Table 1
Snapper Mine and Ginkgo Mine Modification – Responses to Submissions

RE: Snapper Mine and Ginkgo Mine Modification – Groundwater Model

ATTACHMENT 2
PIPER PLOT OF WATER QUALITY

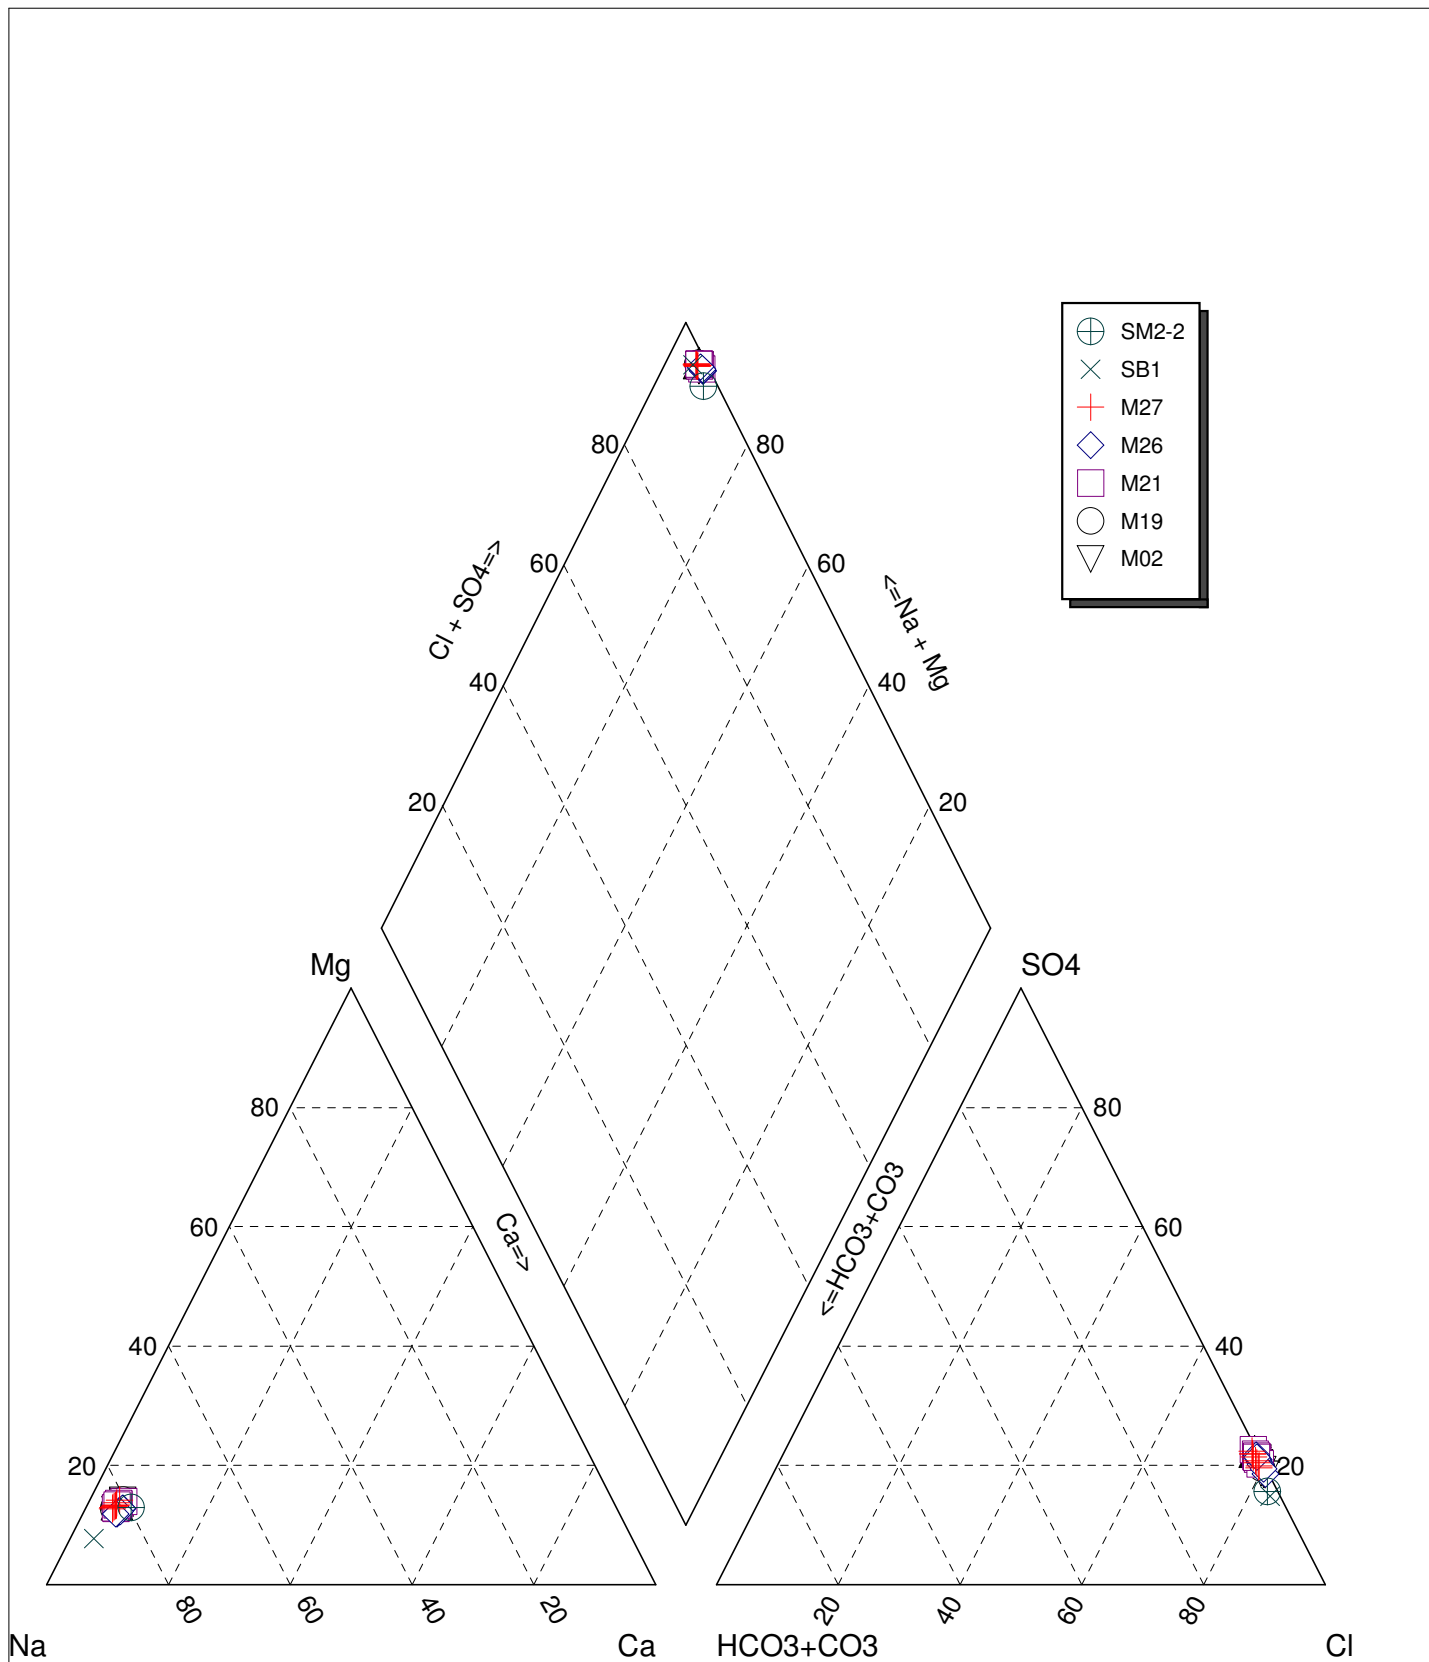
Submitter	Summary of Issue	Comment/Information Request	Response
NSW Office of Water	Water quality – complete analysis.	<p><u>Comment</u></p> <p><i>The Environmental Assessment (EA) has identified the proposal to extract groundwater from a deeper aquifer with the use of only 3 bores in comparison to the original 30 bores in a shallow aquifer. A component of the water extracted from the deeper aquifer is proposed to be recharged into the shallow aquifer. The EA has discussed the water quality of the two aquifers in terms of salinity (TDS) however no other water quality parameters are mentioned. It is therefore necessary for a comprehensive water quality assessment to be completed of both aquifers and is to include as a minimum, an analysis of major ions and pH. An assessment of the impact of mixing water from the two aquifers on the water quality is required.</i></p> <p><u>Information Request</u></p> <p><i>Complete analysis of the water quality of the deep and shallow aquifers targeted by this project and an impact assessment on water quality of the proposed recharge into the shallow aquifer.</i></p>	<p>Attachment 1 provides a comparison of the available water quality data for bores within the shallow Pliocene Loxton-Parilla Sands aquifer and the deep Tertiary Lower Olney Formation/Warina Sand aquifer, between the Darling River and the Great Darling Anabranch. Available water quality data includes the following parameters (including major ions and pH):</p> <ul style="list-style-type: none"> pH; electrical conductivity (EC); total dissolved solids (TDS); chloride; sulphate; bicarbonate; potassium (K); sodium (Na); calcium (Ca); magnesium (Mg); iron (Fe); manganese (Mn); and phosphorus (P). <p>The groundwater monitoring results indicate that the water within the shallow Pliocene Loxton-Parilla Sands aquifer has similar characteristics to water within the deep Tertiary Lower Olney Formation/Warina Sand aquifer (refer to Attachment 2, a Piper plot of the water quality, which shows that the waters from the different aquifers have similar characteristics and the same provenance [i.e. derived from the same geology]).</p> <p>This is consistent with the analysis of total dissolved solids (TDS) described in Section 8.5 of Appendix A of the Modification EA:</p> <p><i>The water drawn from the Lower Olney/Renmark Aquifer has lower total dissolved solids (TDS), than water measured in the upper Loxton-Parilla Aquifer. Thus there will be a slight dilution of the dissolved salt in the upper aquifer around the Snapper Mine as a result of the proposed modification. This change will eventually migrate south over about 100 years. This effect is not expected to be measureable at any receiving environment.</i></p> <p>Given the above, the modified Snapper Mine is not predicted to have any significant impact on groundwater quality of the Loxton-Parilla Sands aquifer.</p>

DESCRIPTION: SM2-2, SB1: Warina Sand: M02, M19, M21, M26, M27: Loxton-Parilla Sands

**SNAPPER HYDROGEOLOGICAL ASSESSMENT GROUNDWATER CONTOURS
PRESENTED IN AHD**

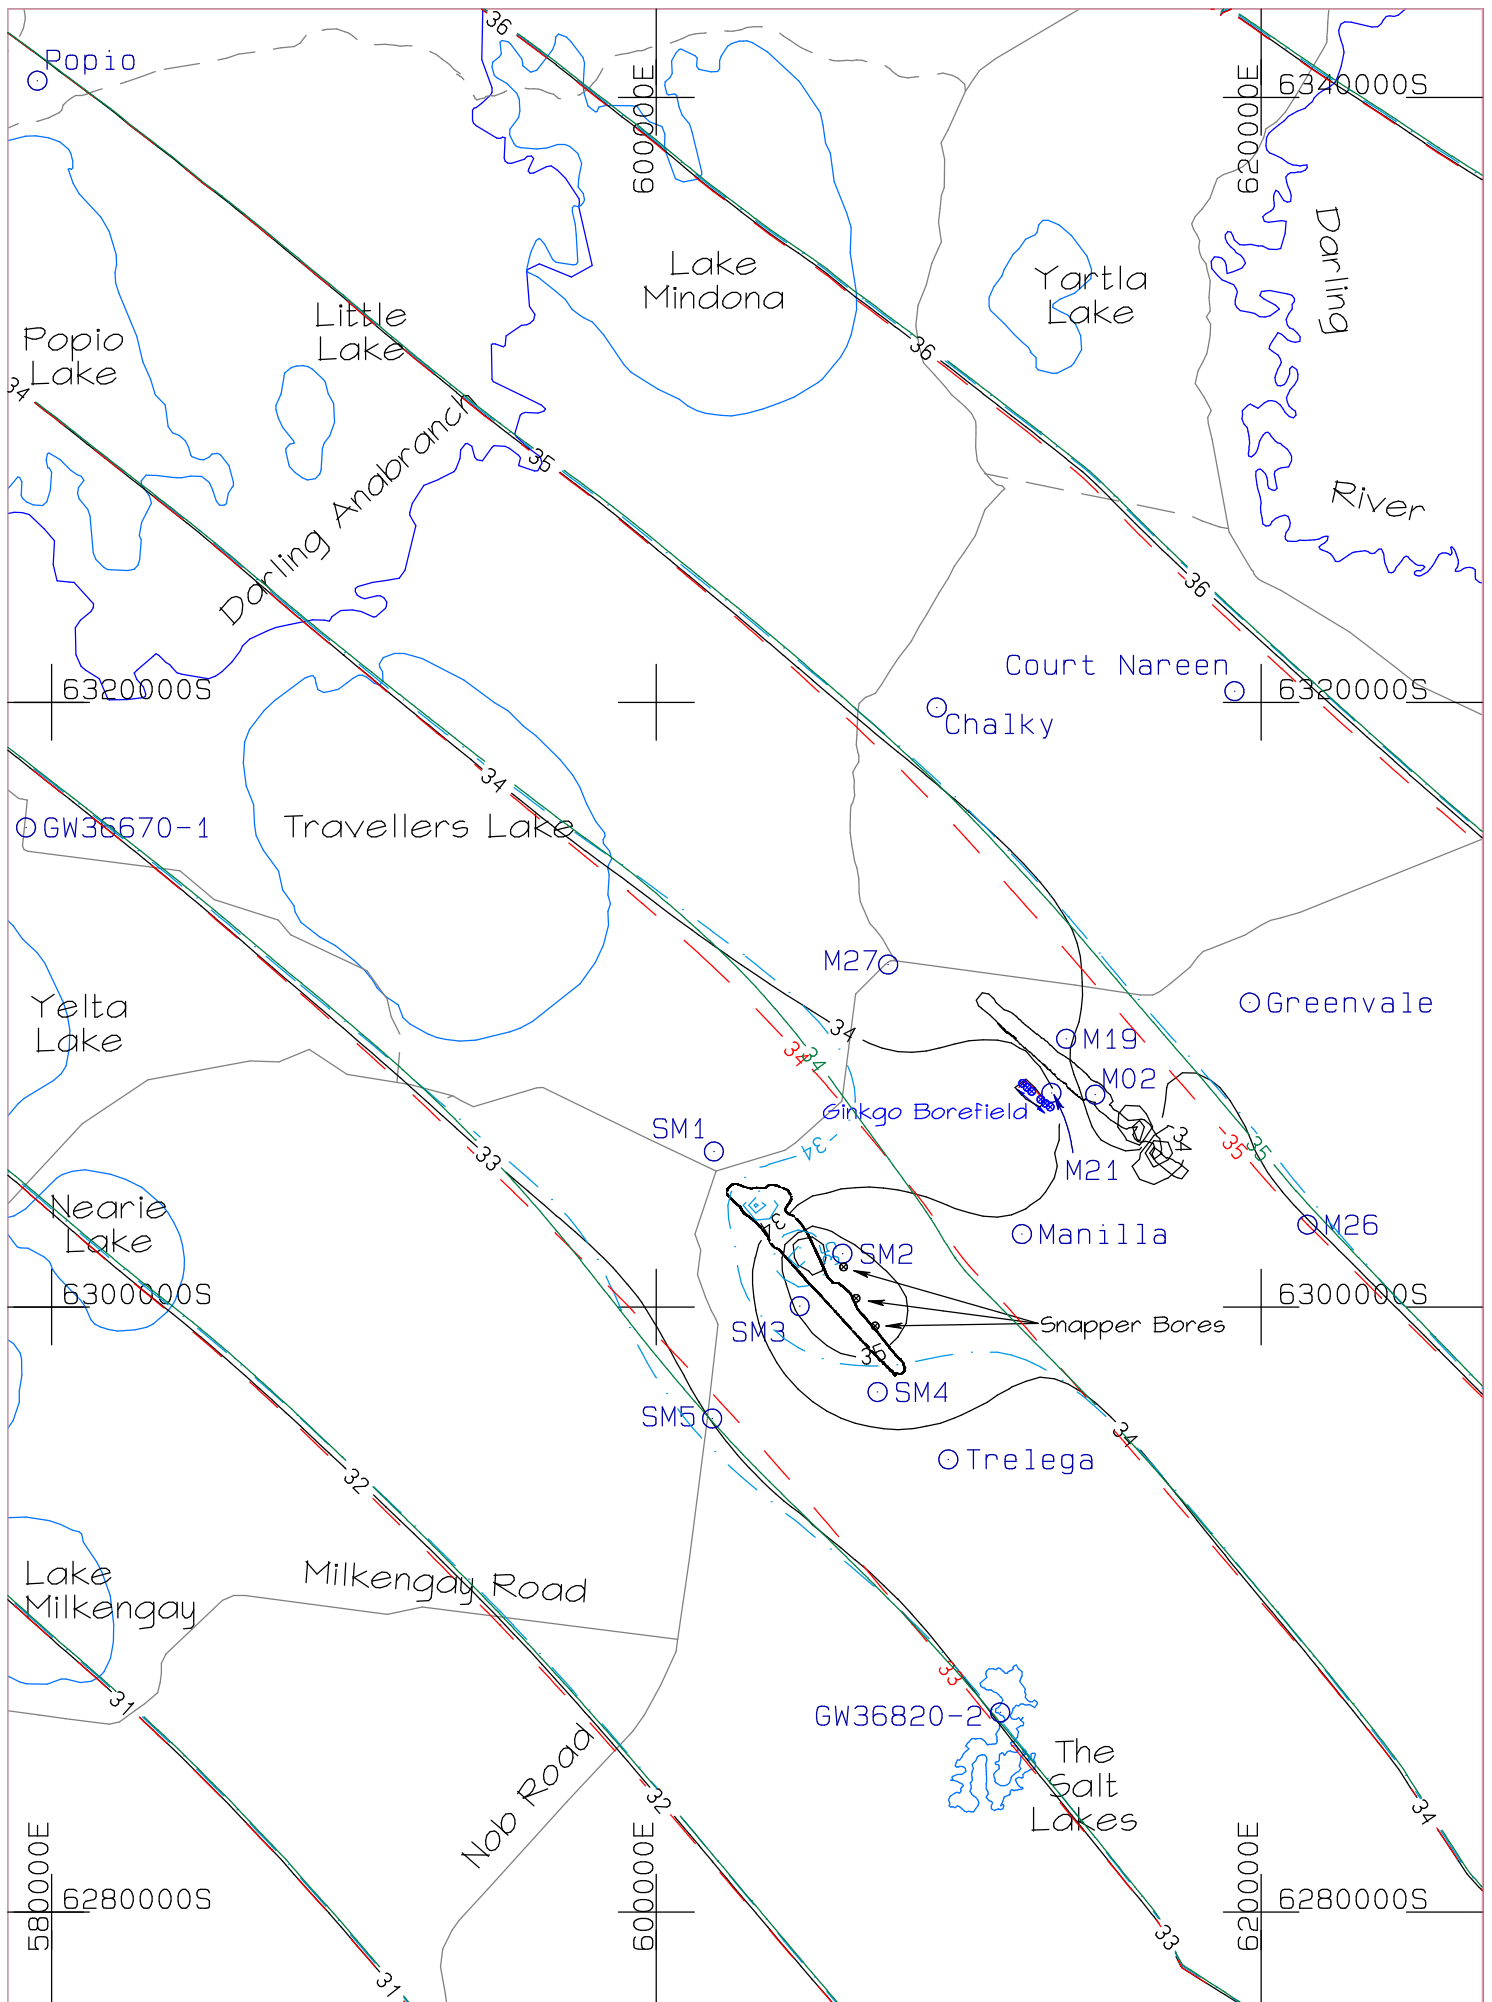
NSW Office of Water	Groundwater levels – presentation in Australian Height Datum (AHD).	<p><u>Comment</u></p> <p><i>The EA does not provide a clear indication in AHD of the existing groundwater level in the area of potential impact and the proximity of this groundwater level to current and proposed infrastructure (eg. Water disposal dam) and ground level. NOW also requires the groundwater contours presented to indicate groundwater response to be provided in AHD.</i></p> <p><u>Information Request</u></p> <p><i>The groundwater level to be presented in AHD in the area of potential impact and the proximity of this groundwater level to existing and proposed infrastructure and ground level. It is also requested for the groundwater contours utilised to represent the groundwater response to be provided in AHD.</i></p>	<p>Attachment 3 provides the desired water disposal dam water levels for each year of the Snapper Mine in relative level (RL) metres (m) Australian Height Datum (AHD). The natural ground level at the site for each year of the Snapper Mine is also provided in Attachment 3 in RL m AHD.</p> <p>The modelling indicated a maximum mounding of the groundwater level beneath the water disposal dam to approximately RL 47 m AHD, (i.e. approximately 13 m above the existing watertable [approximately RL 34 m AHD]).</p> <p>Attachment 4 presents the groundwater contours presented as Appendix C of the Hydrogeological Assessment revised to show groundwater levels in RL m AHD.</p>

19.5 x 26.41		Bemax Resources Snapper & Ginkgo Mines	Upper Aquifer Contours (AHD)		
<div> <div> <div>---</div> <div>Jul 2005 - Pre-Mining</div> </div> <div> <div>---</div> <div>Jun 2017 - 7 Yrs Snapper</div> </div> </div>	<div> <div>---</div> <div>Apr 2025 - End of Mining at Snapper</div> </div> <div> <div>---</div> <div>Apr 2035 - 10 Yr post Mining</div> </div>	<div> <div>Surveyed:</div> <div>BEMAX</div> </div> <div> <div>Plotted:</div> <div>Jun 29 2010</div> </div> <div> <div>Design:</div> <div>GEO-ENG</div> </div>	<div> <div>Contour int:</div> <div>1m</div> </div> <div> <div>DATUMS:</div> <div></div> </div> <div> <div>Hor:</div> <div>GDA</div> </div> <div> <div>Ver:</div> <div>A.H.D.</div> </div> <div> <div>A4 - 1:</div> <div>250000</div> </div>	<div> <div>C:\Vef\low\SSG\import-export\Plots\159\SSG\ContoursAHDv2.pro</div> </div>
